SUBJECT: EDWIN I. HATCH NUCLEAR PLANT, UNITS 1 AND 2 – STAFF
ASSESSMENT OF RESPONSE TO 10 CFR 50.54(f) INFORMATION
REQUEST – FLOOD-CAUSING MECHANISM REEVALUATION
(CAC NOS. MF3868 AND MF3869)

STAFF ASSESSMENT BY THE OFFICE OF NUCLEAR REACTOR REGULATION
RELATED TO FLOODING HAZARD REEVALUATION REPORT
NEAR-TERM TASK FORCE RECOMMENDATION 2.1
EDWIN I. HATCH NUCLEAR PLANT, UNITS 1 AND 2
DOCKET NOS. 50-321 AND 50-366

Figure 3.2-1: Site layout and topography (from FHRR, SNC 2014a)

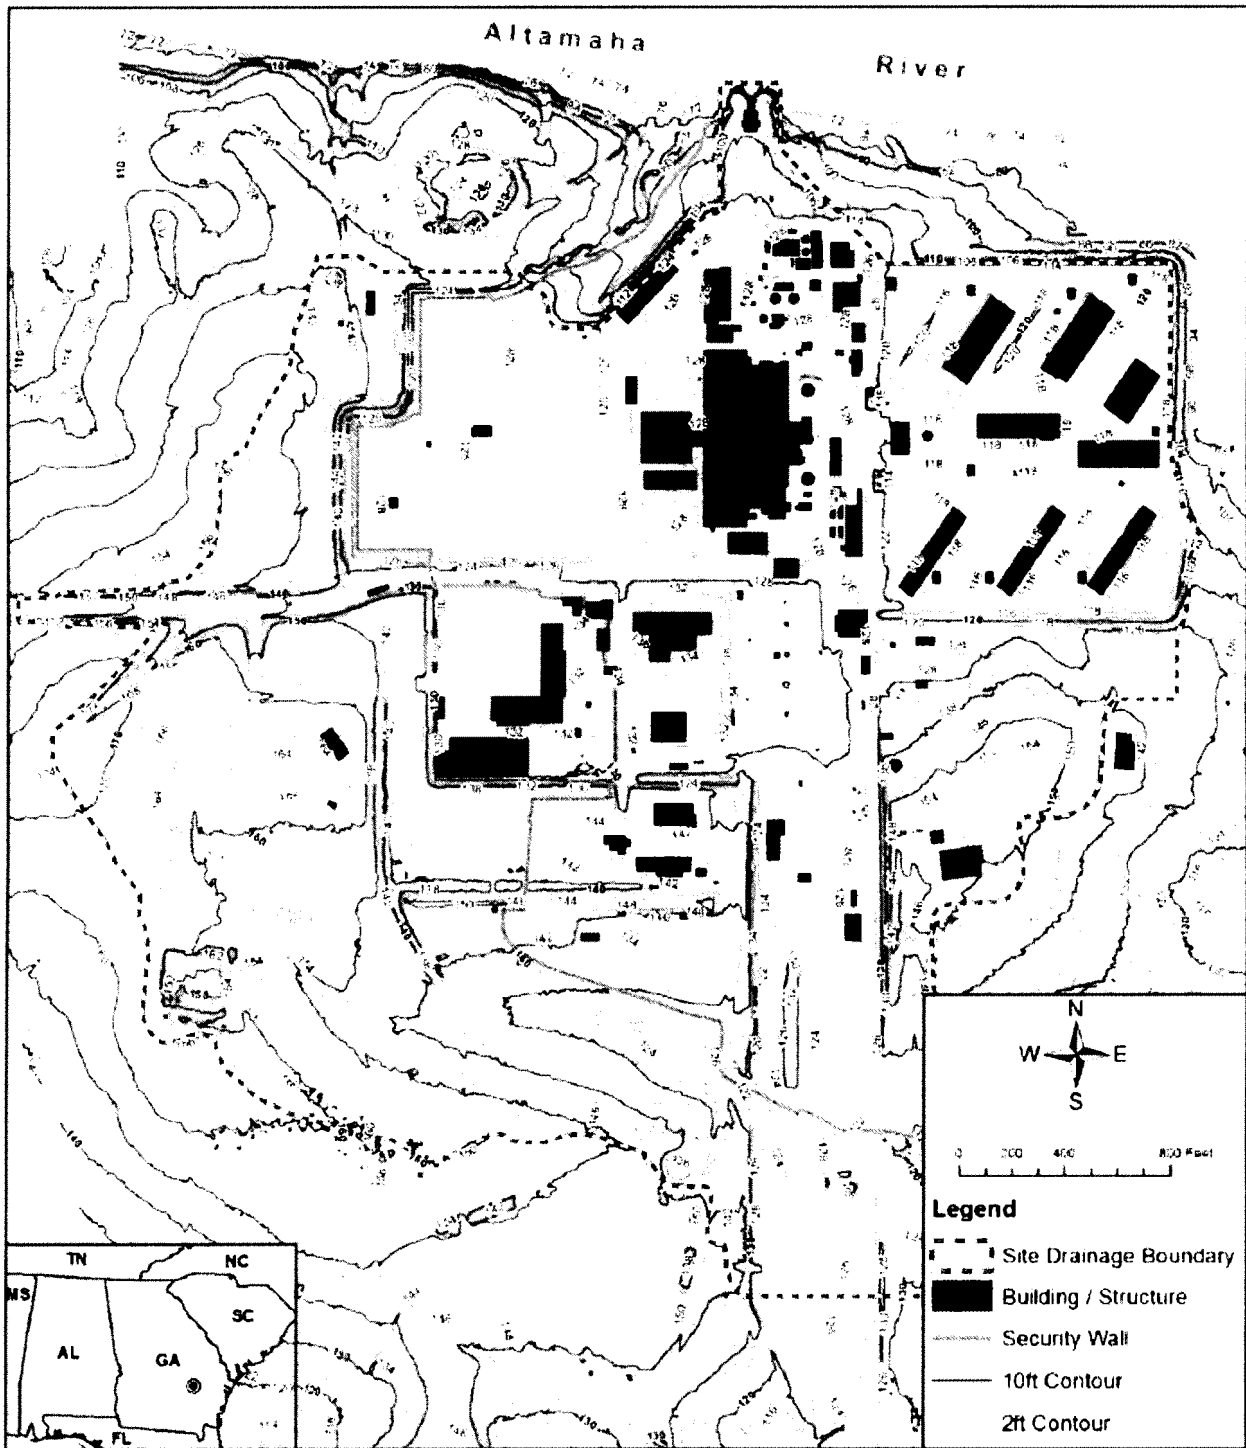
In Section 5 of its FHRR, the licensee stated that its LIP reevaluation was conducted in accordance with NUREG/CR-7046 (NRC, 2011e) and the analysis is based on a precipitation input equivalent to the 1-hour, 1-mi² (2.6 km²) probable maximum precipitation (PMP) event at the HNP site, as determined from Hydrometeorological Report (HMR) 52 National Oceanic and Atmospheric Administration (NOAA) (NOAA, 1982). The licensee used the two-dimensional hydrodynamic computer model FLO-2D Build 2009.06 (FLO-2D, 2009) to simulate runoff resulting from this PMP event. As discussed in the audit report (NRC, 2016b), the FLO-2D model simulates the full catchment basin draining to the site and consists of 122,089 grid elements of size 10-ft (3.0 m) by 10-ft (3.0 m), a resolution which the licensee considered adequate for providing appropriate topographic detail of the site. Topographic data were available through a combination of light detection and ranging (LiDAR), survey, and as-built information. LiDAR data, originally provided in the NAVD88 datum, were converted to the NGVD29, using a conversion that NGVD29 elevations are 0.8 ft (0.24 m) higher than NAVD88 elevations (NRC, 2016b). Figure 3.2-1 shows the site layout and topography, as well as the model domain, security barriers, and buildings.

The concrete blocks, or vehicle barrier system (VBS), were modeled as 3.5 ft (1.07 m) tall levee features within the model. If water exceeds that elevation, flow will occur over the VBS surface according to the broad crested weir equation with a weir coefficient of 2.85. Buildings, tanks, and cooling towers within the site were modeled as flow obstructions by assigning an approximate top/roof elevation based on LiDAR data. Area reduction factor and width reduction factor values were assigned to accurately model flow conditions around the dry storage casks within the southern independent spent fuel storage installation pad (NRC, 2016b). The 1-hour, 1-mi² (2.6 km²) PMP event was developed using HMR 52, with sub-hourly rainfall amounts estimated using figures 36 to 38 (NOAA, 1982). The resulting PMP values are provided in Table 3.2-1. The licensee arranged incremental PMP values following a front-loaded temporal distribution, with the most intense rainfall occurring at the beginning of the event. The FLO-2D model used the rainfall distribution input, including these incremental rainfall depths, with a total simulation time of 24 hours and rainfall distributed evenly across the site. NRC staff compared the licensee's PMP values with HMR 52 and confirmed the licensee's reported PMP values. The staff found the licensee's PMP values were reasonable.

The staff confirmed through review and sensitivity analysis that the selection of model parameters and representation of site features in the model are reasonable. Additionally, the staff confirmed the licensee's conclusion that the reevaluated flood hazard for LIP and associated site drainage is not bounded by the CDB flood hazard. Therefore, the staff expects that the licensee will submit a focused evaluation for LIP and associated site drainage for HNP, Units 1 and 2, consistent with the process and guidance discussed in COMSECY-15-0019 (NRC, 2015b).

Figure 3.3-1: Streamflow and watershed locations (from FHRR, SNC 2014a)

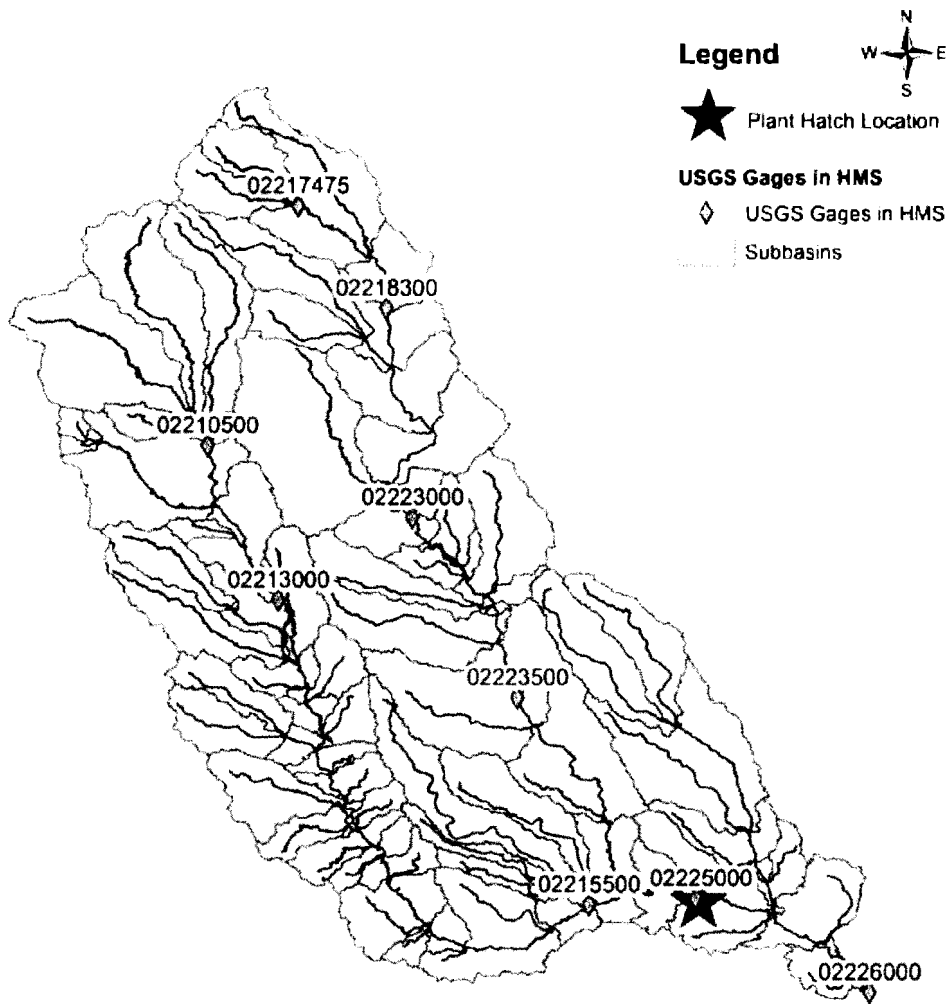
Using a digital elevation model (DEM) of the Altamaha River watershed from USGS, the licensee delineated subbasin boundaries for a total of 76 subbasins, ranging in size from 2 to 717 mi² (0.6 to 218.5 km²). These subbasins were delineated for each USGS stream gauge, tributary confluence, and critical dam within the watershed. Figure 3.3-1 shows the locations of USGS stream gauges and the subbasins.

Figure 3.3-2: Temporal distributions of the critical PMP event (from FHRR, SNC 2014a)

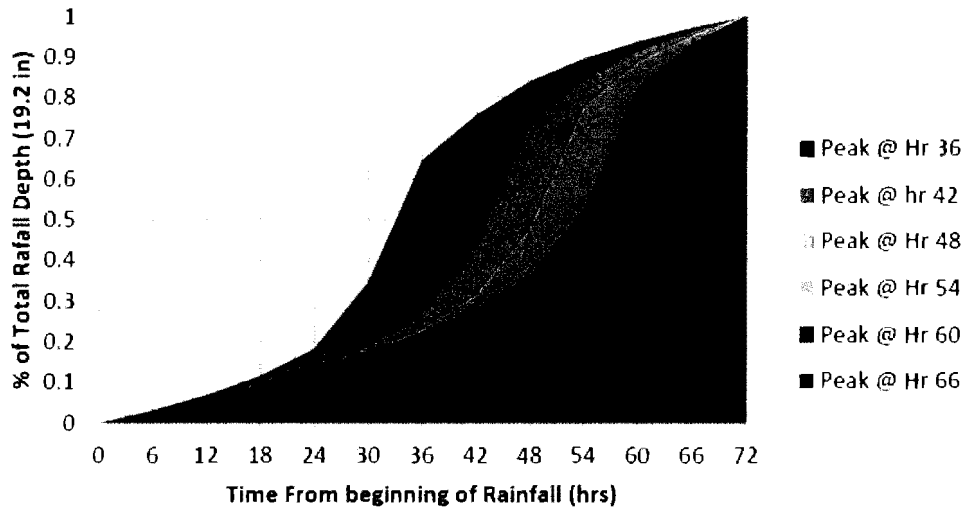
Watershed boundary. The one-hour to six-hour rainfall temporal distribution ratio, preferred storm orientation, and depth-area-duration data were determined from HMR 51 and 52 using the storm center location. The HMR 52 software determined the optimal storm center, orientation, and size combination to maximize watershed rainfall depth and produce the basin-average hydrograph for the probable maximum storm. This approach determined the all-season 72-h PMP value to be 19.20 inches (48.77 cm). To account for long lag times, the 40 percent PMP was added as an antecedent event, followed by a five-day dry period and subsequent full PMP. Six different full PMP temporal rainfall distributions were evaluated to determine the maximum runoff potential, with various combinations of 40 percent PMP distributions also evaluated. The resulting critical storm was a 40 percent PMP preceding a 5-day dry period and full PMP with peak precipitation at 234 hours; the associated peak PMF discharge was found to be 899,636 ft³/s (25,472.8 m³/s) at the HNP site. Figure 3.3-2 shows the various temporal distributions that were evaluated for the PMP event.

The licensee selected a 5-day intermediate dry period rather than a shorter period (e.g., three-day) as recommended by NUREG/CR-7046. The licensee provided a sensitivity analysis suggesting fairly low sensitivity to dry period duration (SNC 2015 and 2016). The NRC staff reviewed the sensitivity analysis and determined that the assumption of a 5-day intermediate dry period is reasonable. Additional details regarding this assumption and the sensitivity analyses are provided in the dam failure flood hazard section of this staff assessment (i.e., Section 3.4).

Figure 3.4-1: Hatch watershed and location of major dams (from FHRR, SNC 2014a)

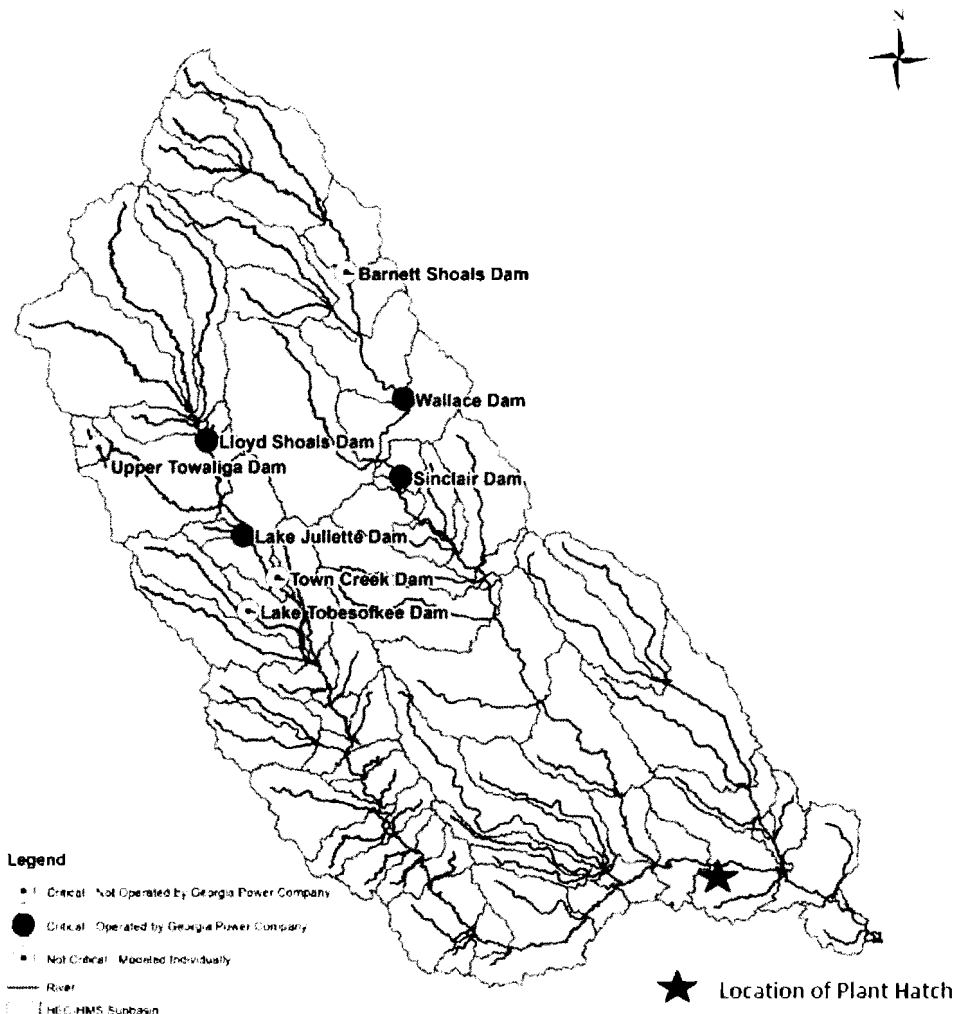
The licensee used the calibrated HEC-HMS model developed for PMF evaluation to simulate the hydrological conditions of the dam failure scenarios. Based on methodology outlined in JLD-ISG-2013-01 (NRC, 2013b), [REDACTED]. Figure 3.4-1 shows the locations of the critical dams considered in the licensee's evaluation. [REDACTED]

Staff finds the licensee's initial dam screening assessment of identifying inconsequential and potentially critical dams to be reasonable.
